Departure from Design Standards DDS-628
Departure from Parking and Loading Standards DPLS-410

Application	General Data	
<p>Project Name: Philmatt-Afrik, Inc.</p> <p>Location: At the intersection of Old Landover Road and Cooper Lane.</p> <p>Applicant/Address: Philmatt-Afrik, Inc. 6690 Old Landover Road Landover, MD 20785</p> <p>Property Owner: PCE, LLC 6690 Old Landover Road Landover, MD 20785</p>	Planning Board Hearing Date:	12/11/14
	Staff Report Date:	11/24/14
	Date Accepted:	09/03/14
	Planning Board Action Limit:	N/A
	Plan Acreage:	0.381
	Zone:	C-S-C
	Gross Floor Area:	4,900 sq. ft.
	Lots:	N/A
	Parcels:	1
	Planning Area:	69
	Council District:	05
	Election District:	02
	Municipality:	N/A
200-Scale Base Map:	204NE06

TECHNICAL STAFF REPORT

SUBJECT: **Departure from Design Standards Application No. DDS-628**
Departure from Parking and Loading Standards Application No. DPLS-410

SITE PLAN

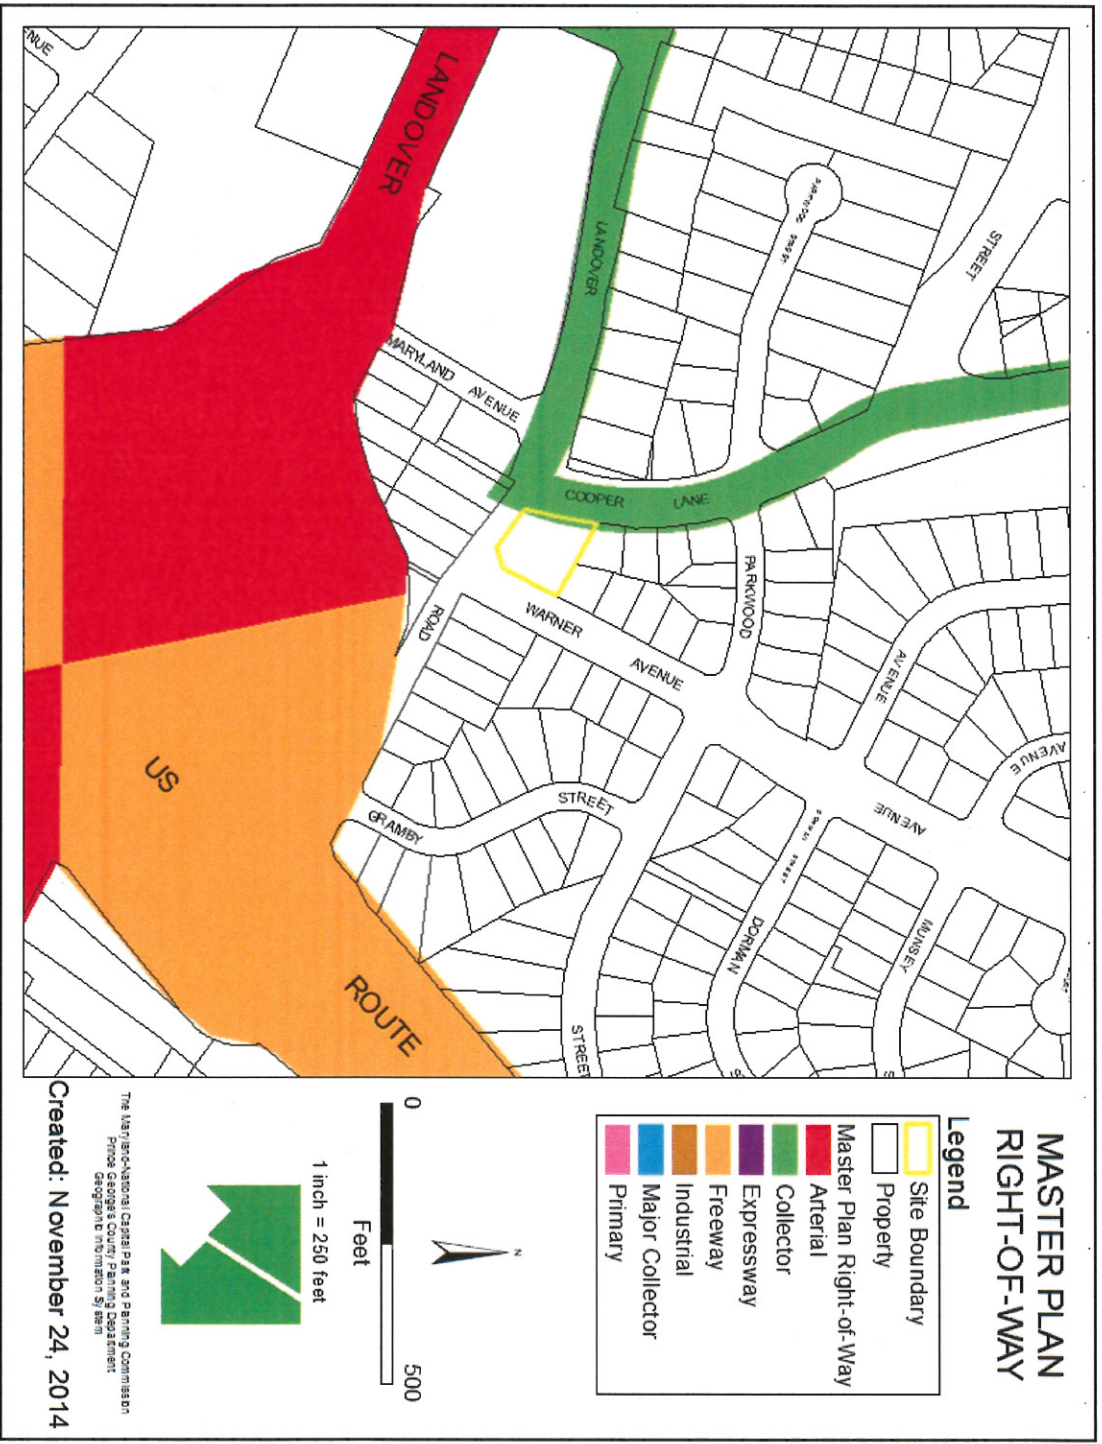
However, General Note 23 indicates that there are no outdoor trash areas on the site, but recent aerial imagery show outdoor dumpsters located in the southeast corner of the site. The Urban Design Section suggests that these dumpsters either be moved internal to the building or be properly screened per Section 4.4 of the Landscape Manual. The subject application is exempt from the requirements of the Prince George's County Tree Canopy Coverage Ordinance, as it will not result in excess of 5,000 square feet of disturbance to the site. The Urban Design Section has no specific comments on the merits of the departure request in regards to the required findings for approval stated in Section 27-239.01(b)(7) of the Zoning Ordinance.

4. **Permit Review Section:** The review of this referral does not include the review of any signage because it is not the subject of this particular application. The location of the dumpster must be demonstrated with required screening, unless information is provided regarding where the trash will be stored. There are striped spaces on the site plan that will have to be removed if they are not in conformance with zoning. It appears that the building was constructed in 1967; the applicant still has the option of using pre-1970 standards for parking and loading. The pre 1970 parking space size is 10 feet by 20 feet, with a minimum 18-foot drive aisle. New parking spaces must be dimensioned at 9.5 by

1. The site plan submitted does not match what is shown on an aerial photograph. The location of the dumpster must be demonstrated with required screening unless information is provided regarding where the trash will be stored. There are striped spaces that are on site that will have to be removed if they are not in conformance with zoning.

2. Dimension of the drive aisle must be provided on the site plan. It appears that the building was constructed in 1967, the applicant still has the option of using pre-1970 standards for parking and loading. Pre 1970 parking space size are 10 feet by 20 feet with a minimum of 18 foot drive aisle. New parking space size must be dimensioned at 9.5 by 19 feet in size. Compact parking spaces must also be dimensioned. Drive aisle widths for new parking must be shown on the site plan at 22 feet in size.

4. The site plan shall be reviewed to demonstrate the right-of-way and centerline of all streets.
5. The height and number of stories must be provided on the site plan

7. The site plan must be revised to demonstrate a ramp or depressed curb for handicap purposes.
8. The parking schedule is unclear, depending on the total square footage and number of stories will determine the parking required. The building previously had multiple tenants in it. The parking schedule shall clearly identify the total square footage of the building. The parking and loading ratio must be provided on the parking schedule.
9. The parking area across the street should be removed from the site plan, it has not been reviewed and should not be included in this request.

1. The site plan submitted does not match what is shown on and aerial photograph. The location of the **dumpster** must be demonstrated with required screening unless information is provided regarding where the trash will be stored.. There are stripped spaces that are on site that will have to be removed if they are not in conformance with zoning. *(Dumpster (along w/ Bd-On Bd Fence) & Fence detail shown on plan)*

2. Dimension of the drive aisle must be provided on the site plan. It appears that the building was constructed in 1967, the applicant still have the option of using pre-1970 standards for parking and loading. Pre 1970 parking space size are 10 feet by 20 feet with a minimum of 18 foot drive aisle. New parking space size must be dimensioned at 9.5 by 19 feet in size. Compact parking spaces must also be dimensioned. Drive aisle widths for new parking must be shown on the site plan at 22 feet in size *(Drive aisle widths & current parking dimensions shown on plan)*

4. The site plan shall be reviewed to demonstrate the right-of-way and centerline of all streets. *(R.O.W. & centerlines of adjacent streets shown on plan)*

5. The height and number of stories must be provided on the site plan *(Height & Existing bldg stories shown on plan)*
6. Section 27-568(b) below allows for a reduction in the number of required parking spaces is interior green is added. *(No interior green proposed)*

7. The site plan must be revised to demonstrate a ramp or depressed curb for handicap purposes (Ramp for H/C parking shown on plan)

9. The parking area across the street should be removed from the site plan, it has not been reviewed and should not be included in this request.

1. Prior to certification of the site plan, the applicant shall correct General Note 19 and remove General Note 23.
2. Prior to issuance of permits, the applicant shall apply for a standard exemption from the Prince George's County Woodland and Wildlife Habitat Conservation Ordinance.
3. Prior to issuance of permits, all trash dumpsters should either be moved internal to the building or be properly screened per Section 4.4 of the 2010 *Prince George's County Landscape Manual*.

(Parking area removed from plan)
